HANDZ CLOTHING BD LTD.

RSC RMG SUSTAINABILITY COUNCIL

1. Executive Summary

Observation 1: Lack of lateral stability (Main Production Shed).

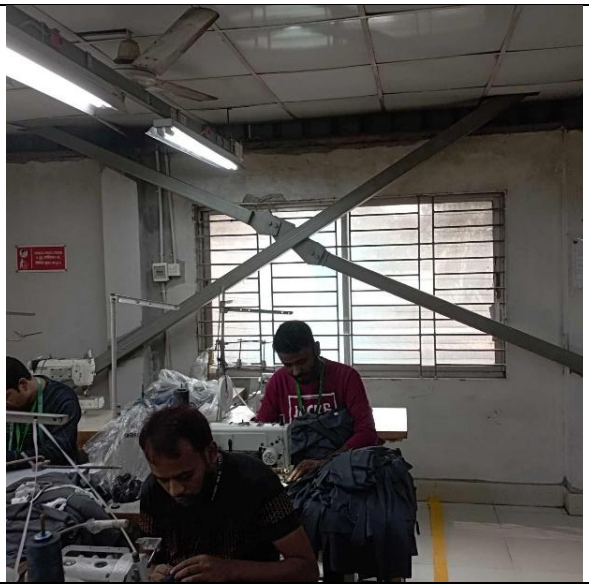
Description: Lateral load transfer media is not provided to transfer the lateral load. The building engineer is required to check the lateral stability of the structure as part of the DEA and propose a remediation plan if required. Verify in situ steel strength.
Observation 2: Lack of a geotechnical investigation report (Main Production Shed).

Observation 3: Faulty connection in vertical bracing (Main Production Shed).

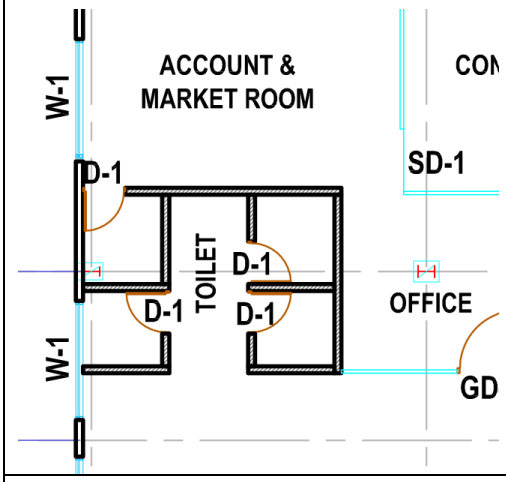
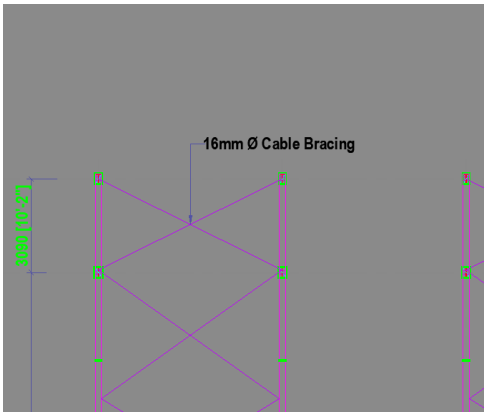
Description: Faulty connection in vertical bracing. As the bracing is not straight, the lateral load is not transferred properly. The building engineer is required to check the load path and connection adequacy and propose a remediation plan.

Observation 5: Discrepancy and missing information in the provided drawing (Main Production Shed).

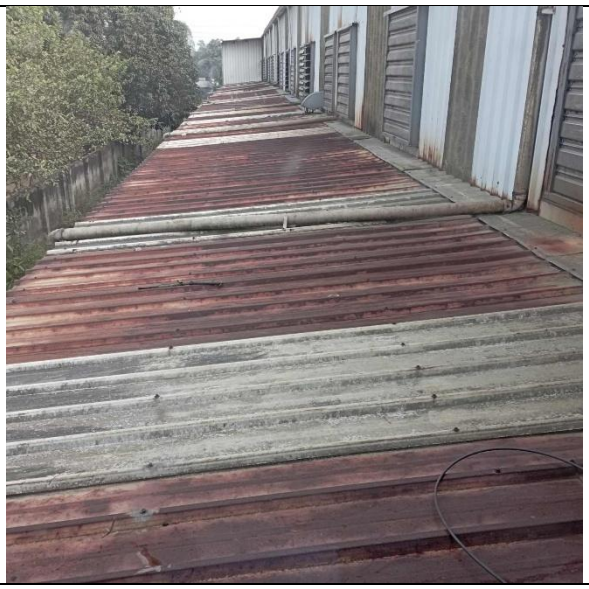
Description: The floor build-up, false ceiling were not shown in the drawing. Also, the diameter of the cable roof bracing was found 12mm but shown as 16mm. The building engineer is required to update the as-built drawing.

Observation 6: Corrosion on steel members (Main Production Shed).

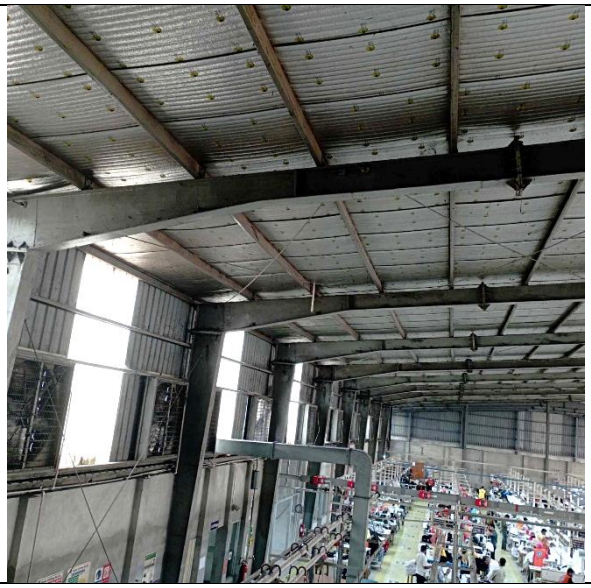
Description: Corrosion was observed on steel members at several locations. The building engineer is required to remove the corrosion and provide rust-proof paint on steel members.

Observation 7: Loose cable bracing (Main Production Shed).

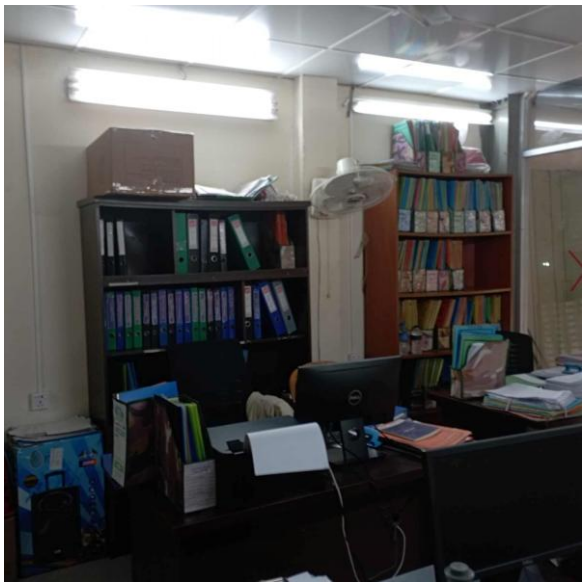
Description: Loose cable bracing was found. Tighten all loose bracings.

Observation-8: Non-structural elements found unanchored/braced (Main Production Shed).

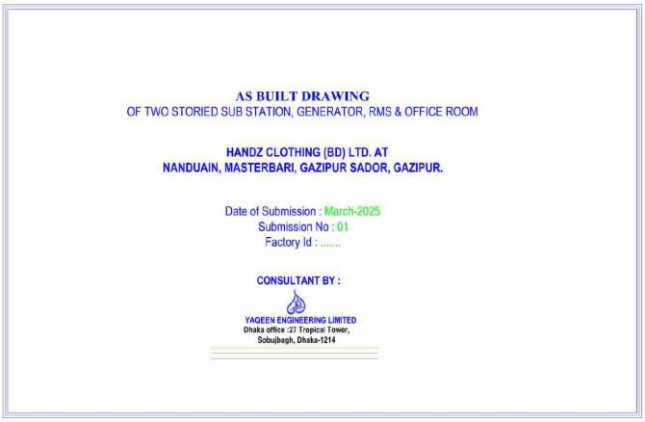
Description: Nonstructural elements were found unanchored/unbraced. The building engineer is required to anchor/brace all nonstructural elements within the factory.

Observation-12: Exposed rebar on the roof level. (Generator & Substation Building)

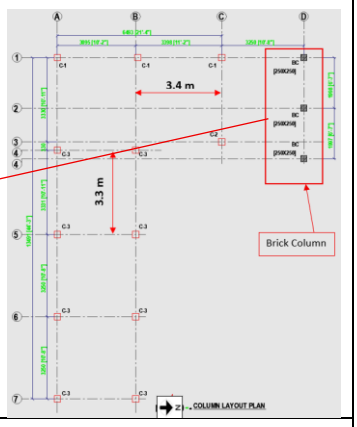
Description: Exposed rebar was observed on the roof, which is prone to corrosion. The building engineer is required to provide anti-corrosive coating on the exposed rebar.

Observation 13: Apparently non-engineered connection/Shed. (Medical & Childcare Shed)

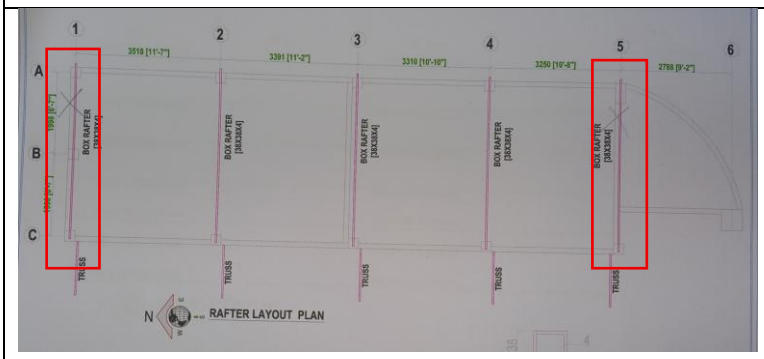
Description: Steel rafter (box section) rested on the brick wall. The building engineer is required to check the adequacy of the connection of the lightweight roof against the uplift pressure of the wind as part of the engineering assessment. Also, three brick columns are shared by the Generator & Substation Building and the Medical & Childcare Shed. The building engineer is required to separate the connection and provide a new column for the structure. Otherwise, analyze these buildings as a single structure.
